NORTHWEST GEORGIA REGIONAL COMMISSION

Subject: Report on DRI 3656 West Dallas LLC Materials Recovery Facility

WEST DALLAS LLC
CITY OF DALLAS, GA
SPECIAL LAND USE APPLICATION

MATERIALS RECOVERY FACILITY
FIGURE 1.0
CONCEPTUAL SITE PLAN

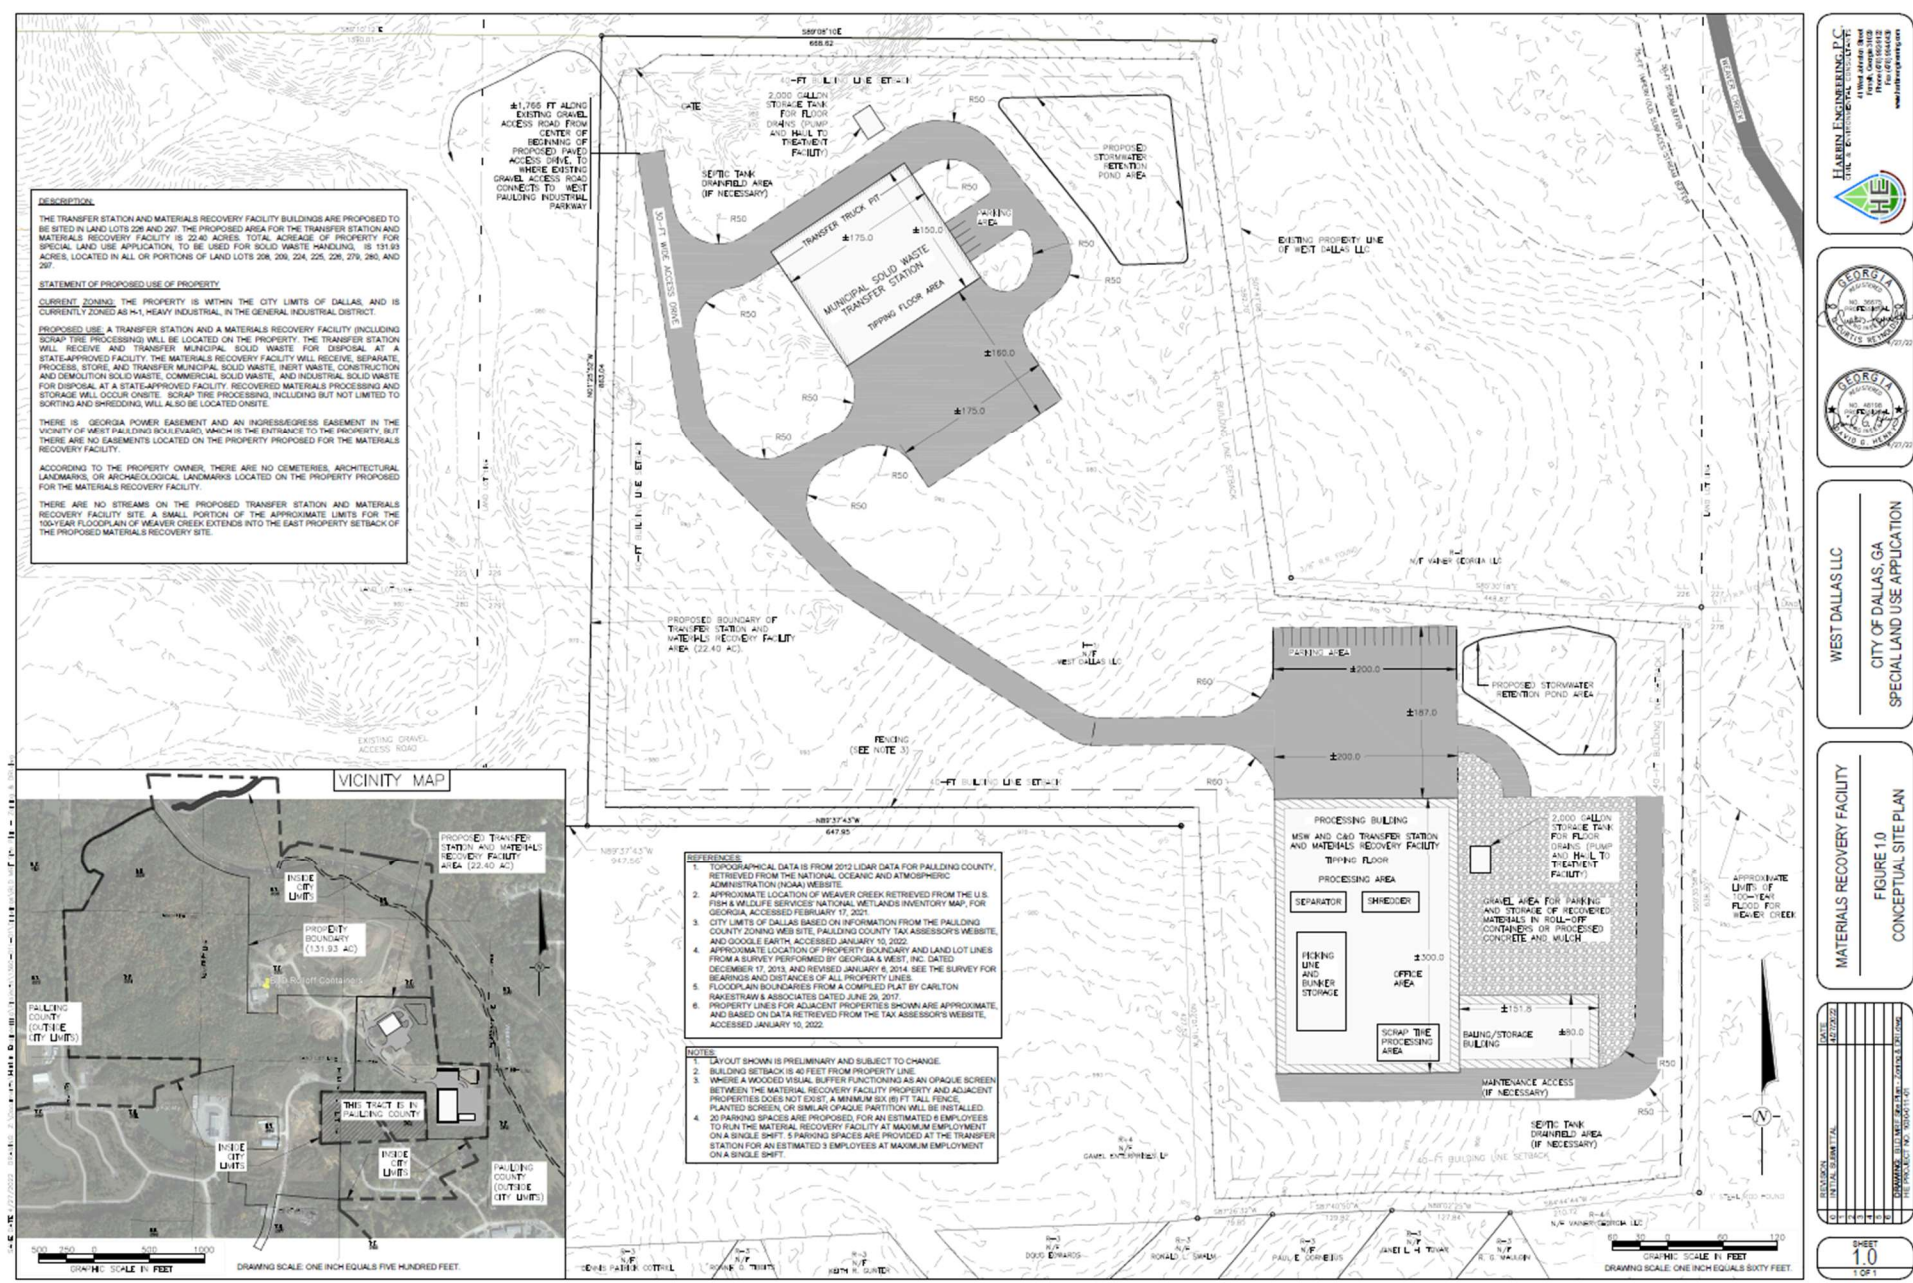
- The site plan appears to conflict with the written narrative: the site plan references W. Paulding Industrial Parkway, and the narrative and existing mapping software references W. Paulding Blvd.

Attachments:

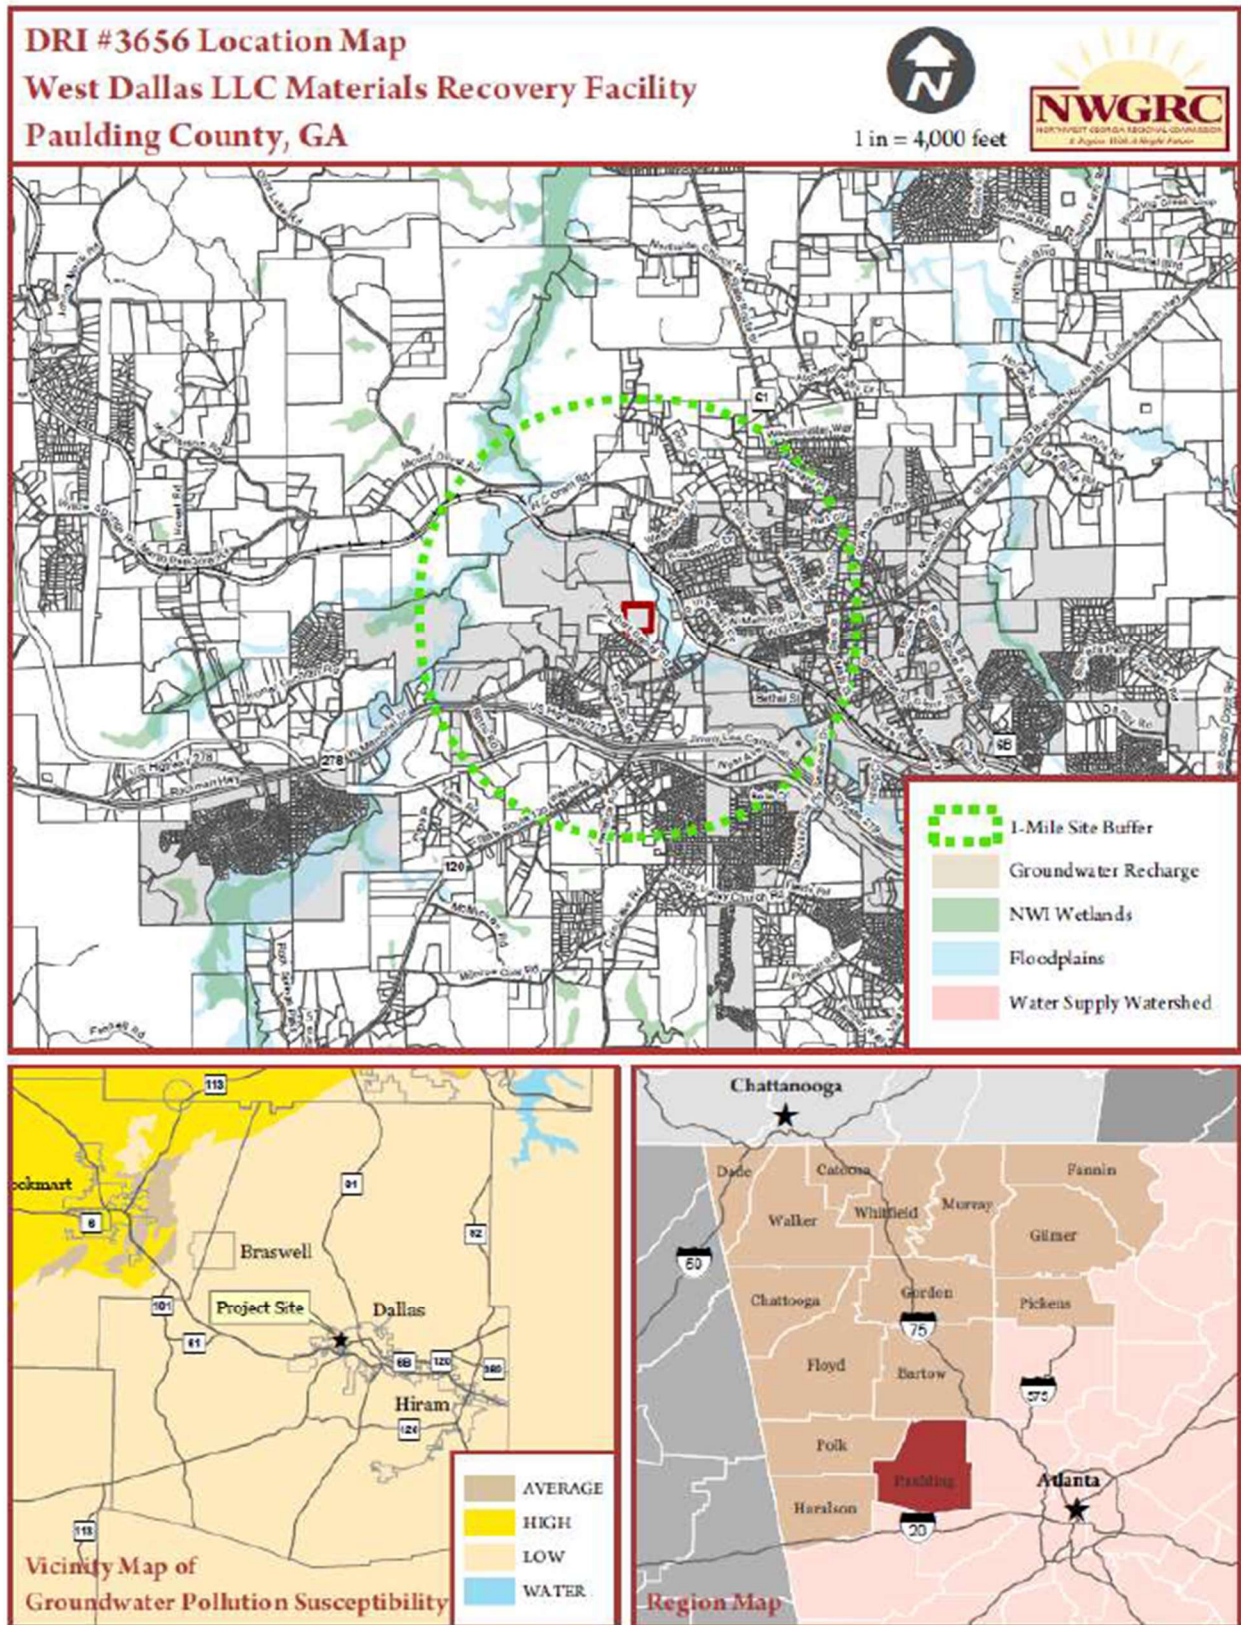
COMMENTS:	<p>From inspection of the effective Flood Insurance Rate Maps (FIRMs) developed by the Federal Emergency Management Agency (FEMA), the proposed project is located outside of the Special Flood Hazard Area (SFHA), in Zone X (unshaded), an area of minimal flood hazard. A Floodplain Snapshot Map showing the designated floodplain impacts in the vicinity of the project location, accompanied by the relevant extract of FEMA's FIRM are attached.</p> <p>Please note that this response addresses issues related specifically to the possible effects of the project on floodplains in the area and does not override or supersede any State or local procedural substantive provisions which may apply to floodplain management requirements associated with amendments to State or local floodplain zoning ordinances, maps, or State or local procedures adopted under the National Flood Insurance Program.</p>
